MAPA Meeting – October 27, 2020

Recent and Upcoming Policy Changes

733.2 Material. All material shall be in accordance with Division 1000, Materials, and specifically as follows:

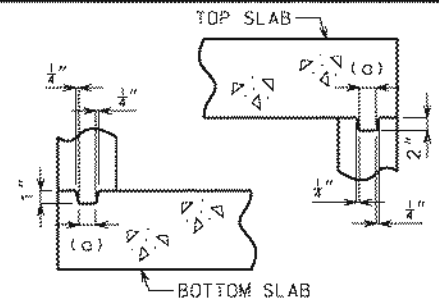
2. Section 733.2 and 733.3.2.1.1, changed subsurface drainage geotextile to separation geotextile.

Item	Section
Subsurface Drainage Separation Geotextile	1011
Precast Concrete Box Culverts	1049
Plastic Joint Compound for Vitrified Clay and Concrete Pipe	1057
Tubular Joint Seal	1057
Mortars and Grout	1066

TRANSVERSE JOINT THRU BARREL

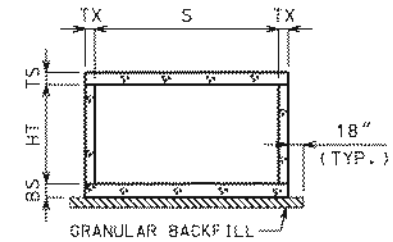
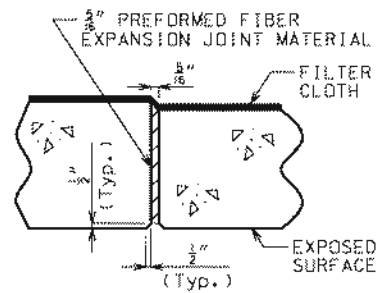
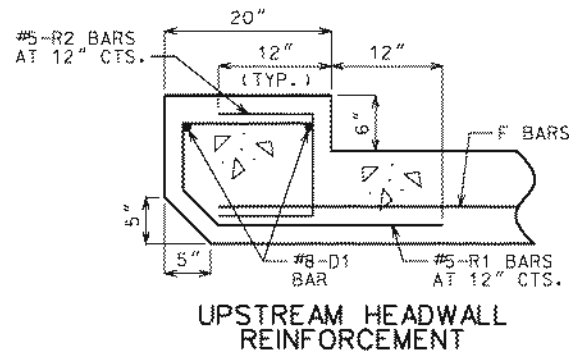
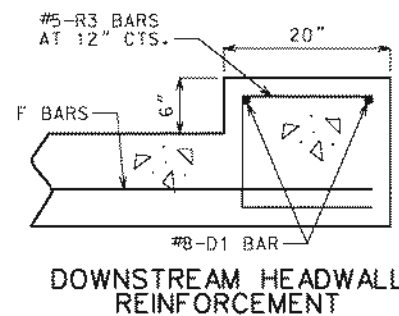
4. Multiple 703 Std. Plan sheets - replacing Subsurface Drainage with Separation.

FILTER CLOTH 3 FEET IN WIDTH AND DOUBLE THICKNESS SHALL BE CENTERED ON TRANSVERSE JOINTS IN TOP SLAB AND SIDEWALLS WITH EDGES SEALED WITH MASTIC OR TWO SIDED TAPE. FILTER CLOTH SHALL BE A ~~SUBSURFACE DRAINAGE~~ GEOTEXTILE IN ACCORDANCE WITH SEC 1011. COST OF FURNISHING AND INSTALLING FILTER CLOTH WILL BE CONSIDERED COMPLETELY COVERED BY THE CONTRACT UNIT PRICE FOR OTHER ITEMS.

HANDRAILING

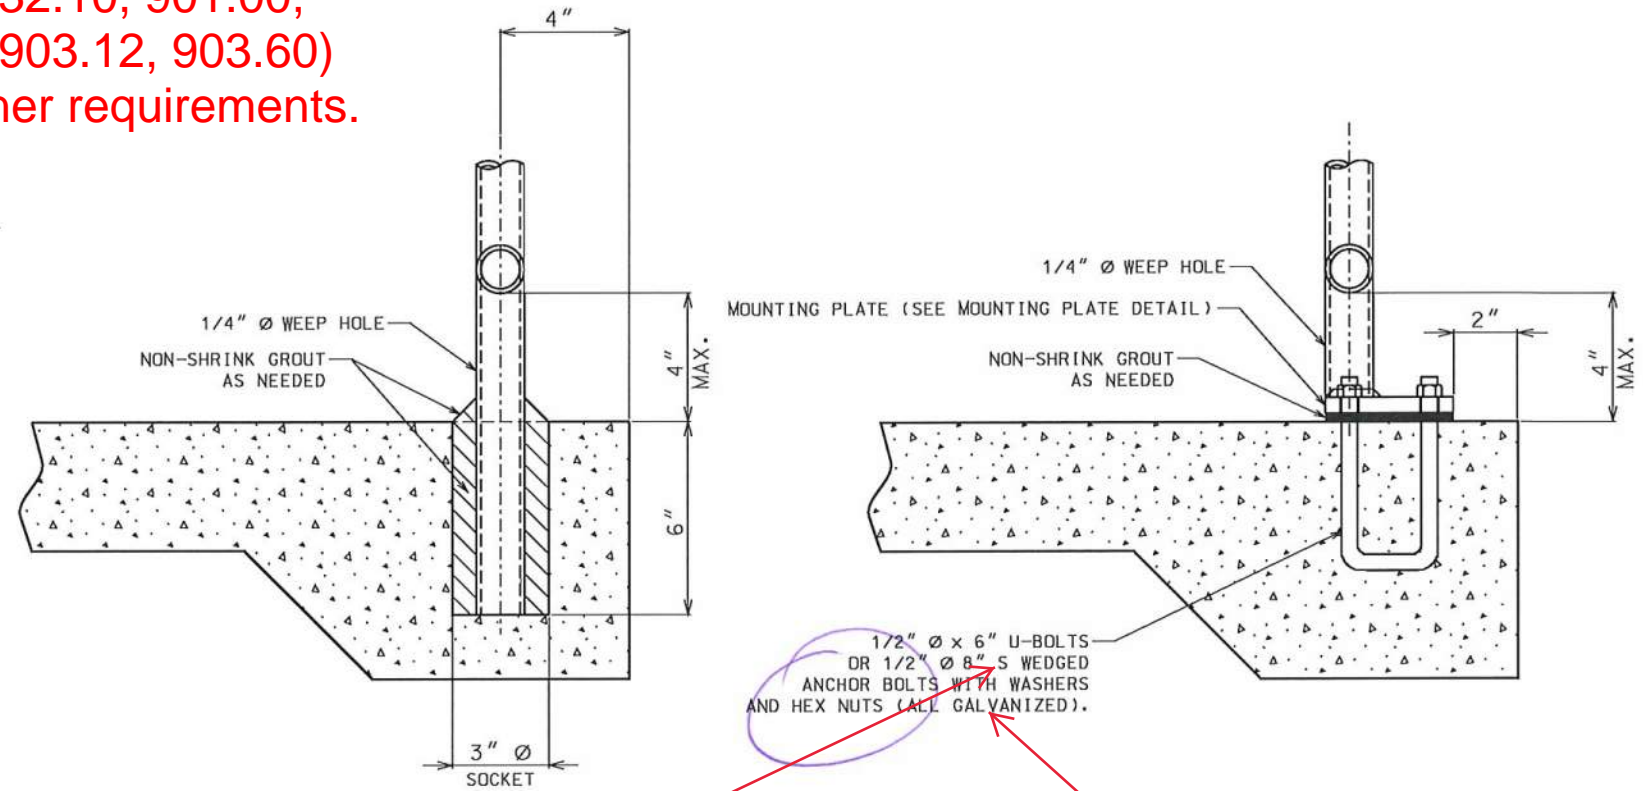
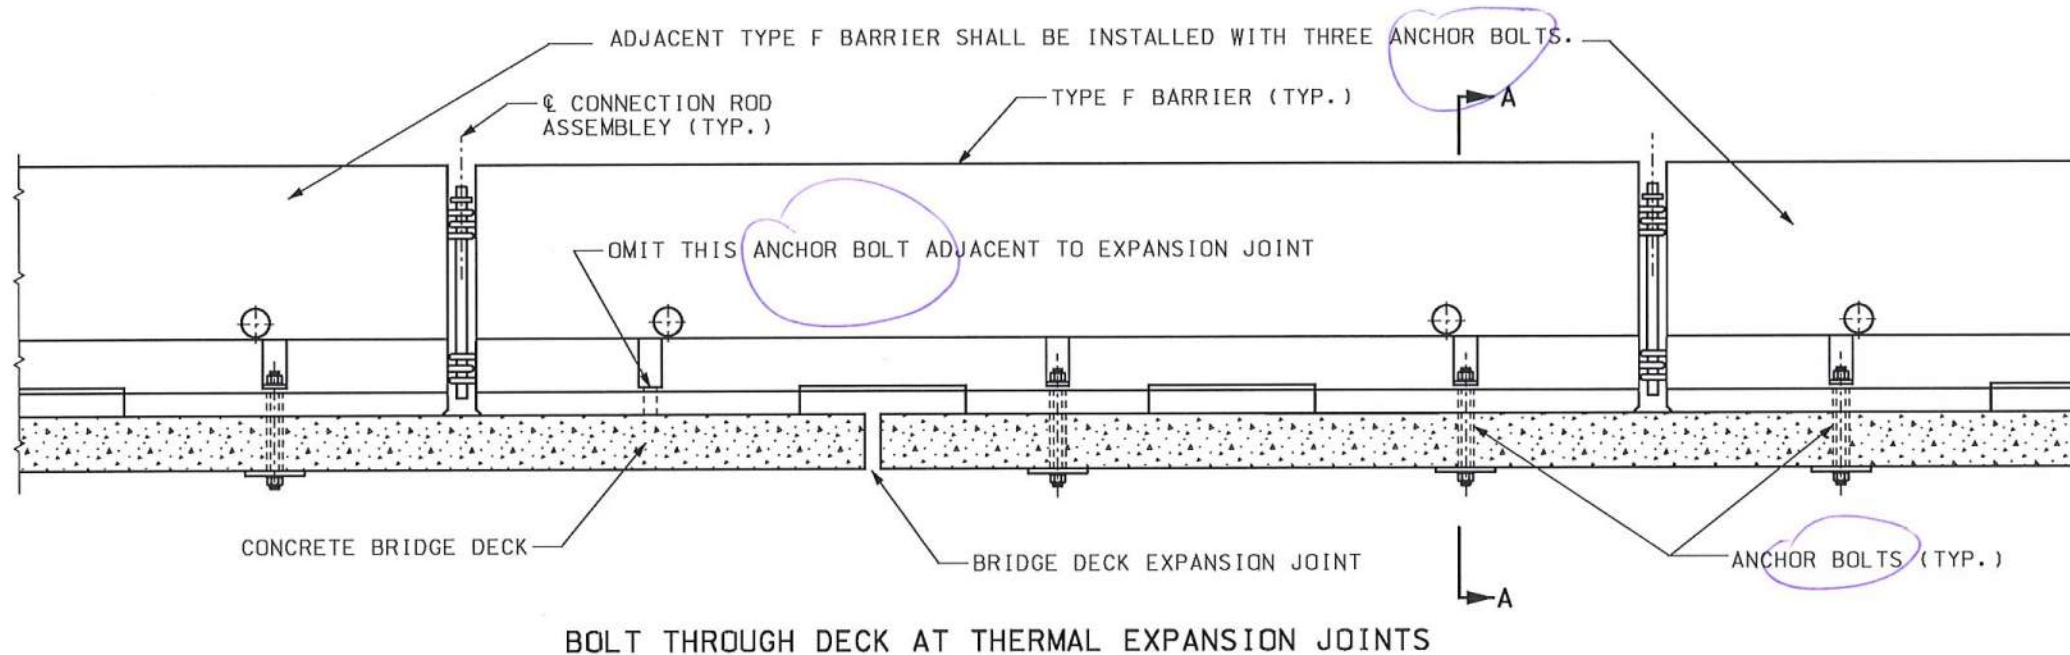
5. Multiple Std. Plans (608.40, 614.11, 617.20, 732.05, 732.10, 901.00, 901.01, 902.10, 902.70, 903.03, 903.05, 903.06, 903.10, 903.12, 903.60) updated ASTM galvanizing requirements and other fastener requirements.

SHALL BE GALVANIZED IN ACCORDANCE WITH AASHTO M 232 (ASTM A153), CLASS C.

GENERAL RAILING COMMERCIAL STEEL RAILING ACCORDANCE WITH AASHTO M 232 (ASTM A153), CLASS C. ROUND OR SQUARE STEEL OF GOOD LUMINUM ALLOY 6061-T6 OR 6063-T6. GALVANIZED AFTER FABRICATION IN ACCORDANCE WITH AASHTO M 232 (ASTM A153), CLASS C.

BOLT THROUGH DECK DETAIL

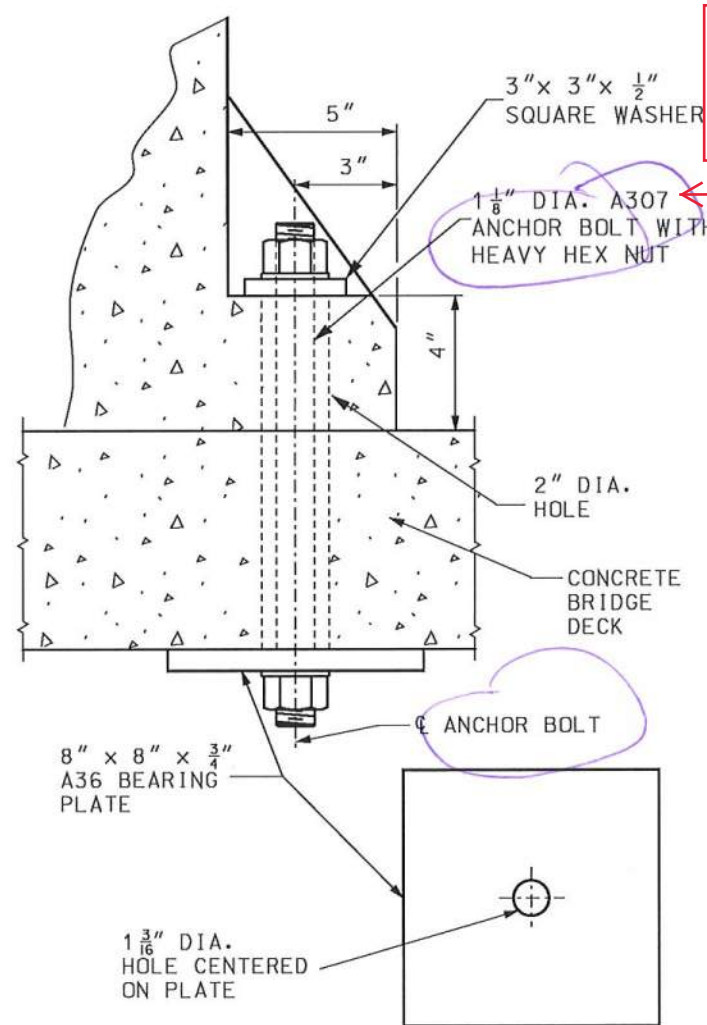
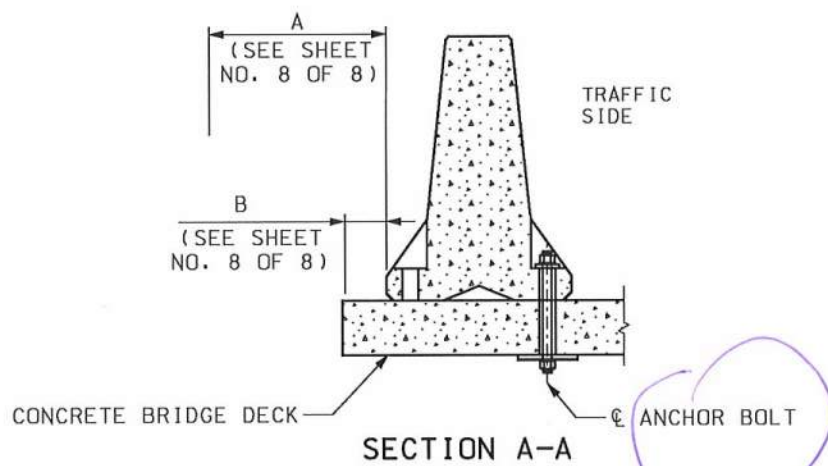
I agree. Use HEX.

1 1/8" dia. ASTM A307 ANCHOR BOLT WITH HEX NUT
